UNITED STATES PATENT AND TRADEMARK OFFICE

APPLICATION NO.	FILING DATE	FIRST NAMED INVENTOR	ATTORNEY DOCKET NO.	CONFIRMATION NO.
10/733,568	12/12/2003	Satoshi Kojima	03500.017762.	8616
5514 7590 08/06/2007 FITZPATRICK CELLA HARPER & SCINTO 30 ROCKEFELLER PLAZA NEW YORK, NY 10112			EXAMINER DOTE, JANIS L	
			ART UNIT 1756	PAPER NUMBER
			MAIL DATE 08/06/2007	DELIVERY MODE PAPER

Office Action Summary

1. This office action is responsive to the responses to the *Ex parte Quayle* action mailed on Dec. 20, 2006 ("*Quayle* action"), filed on Feb. 22, 2007, May 23, 2007, and on Jun. 27, 2007.

FIG. 1

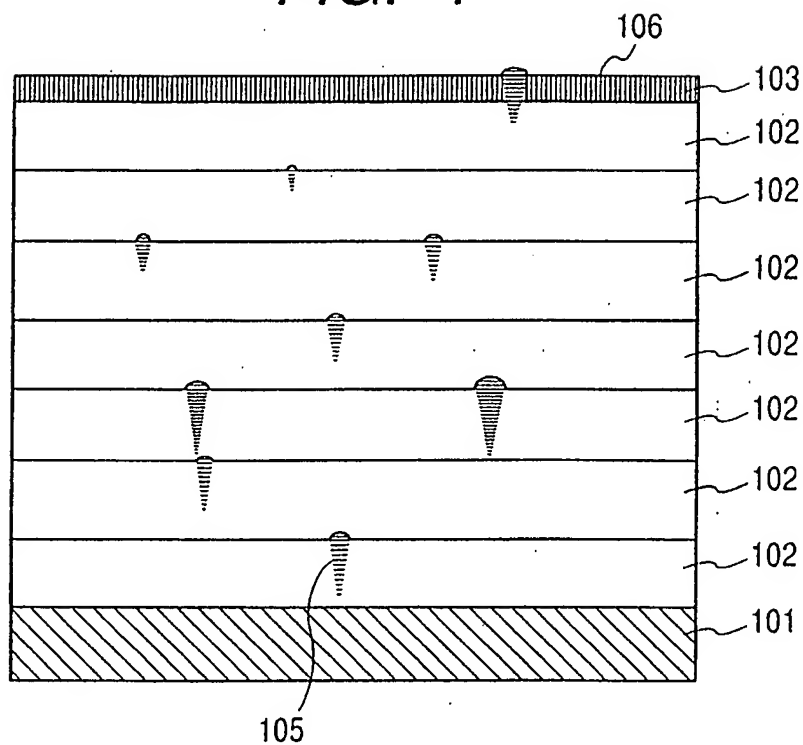
OK to enter
acceptable
of date
5/31/07

FIG. 5

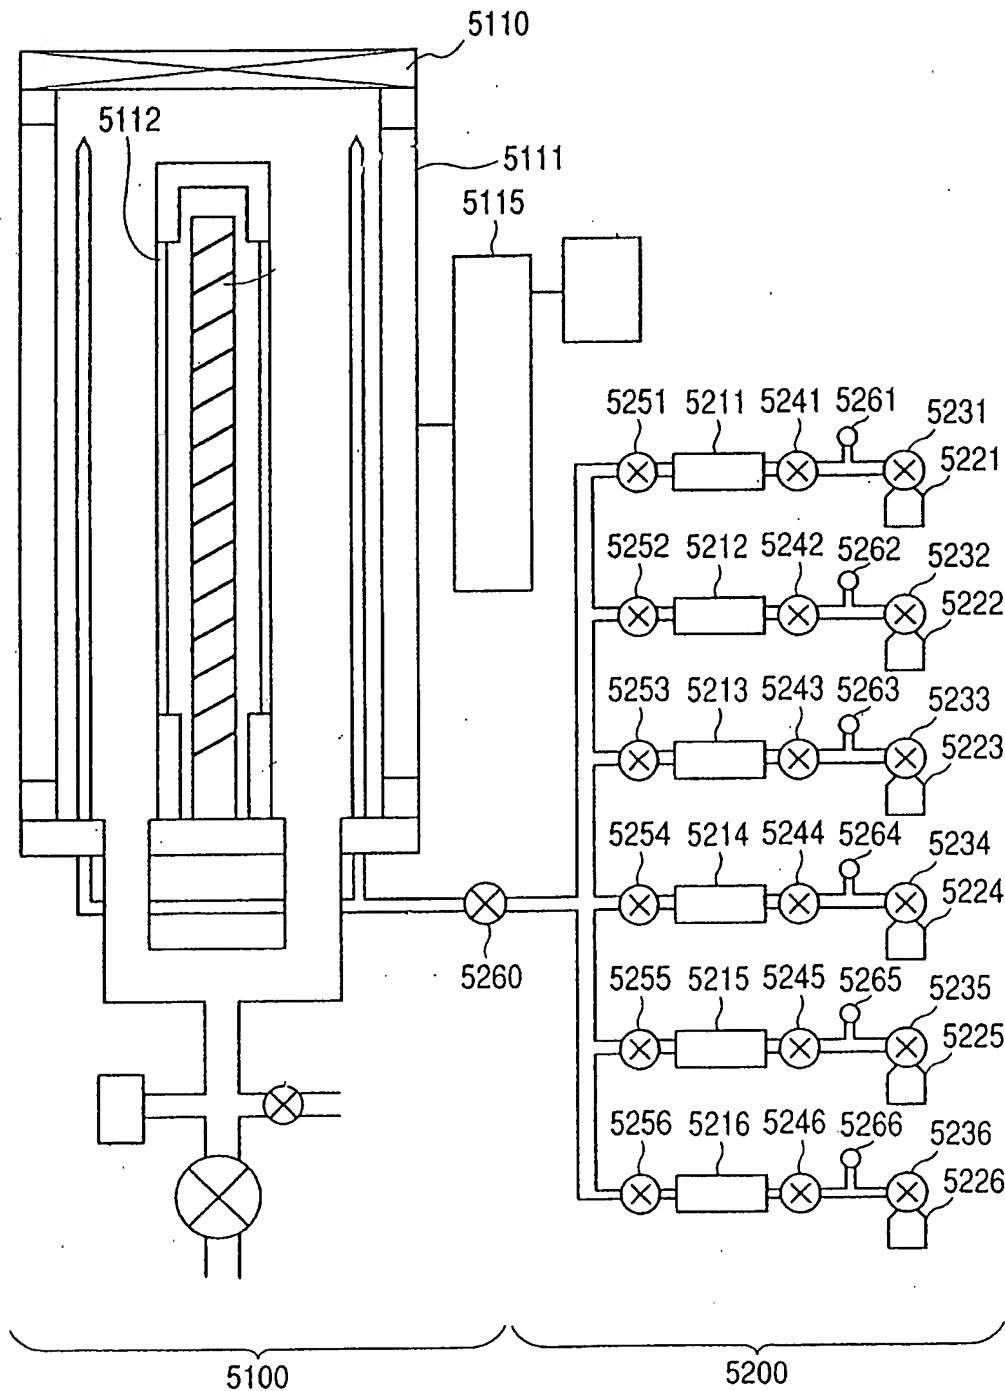
OK to enter
7/31/07
J. D. D.
